**COMMUNICATIONS ALLIANCE  
SATELLITE SERVICES WORKING GROUP**

SUBMISSION

Apparatus licences in the 3.4–4.0 GHz band in  
remote Australia - Licensing, allocation process,  
technical framework and pricing arrangements

4 May 2022

**Figure 1: Second FSS Rx above WBB Tx**

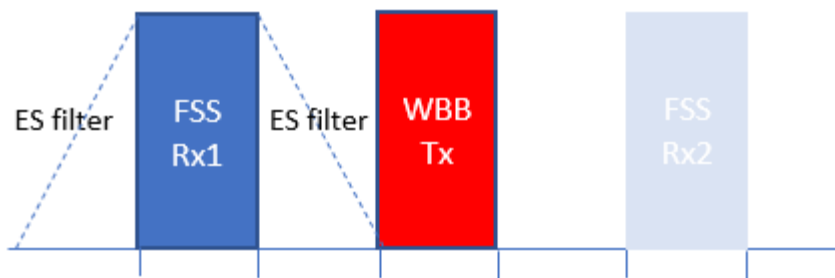
- (e) Often there are multiple carriers licensed on the same antenna. If the 'theoretical' filter assumptions in Table 7 of the draft RALI MS47 are used, and a

second FSS Rx carrier was required on the same antenna, the band-pass filter would not allow the FSS Rx2 signal to be received by the earth station receiver. This limitation would apply for both a second FSS Rx operating above the WBB Tx (see Figure 1) or for a second FSS Rx operating below the WBB Tx (Figure 2).
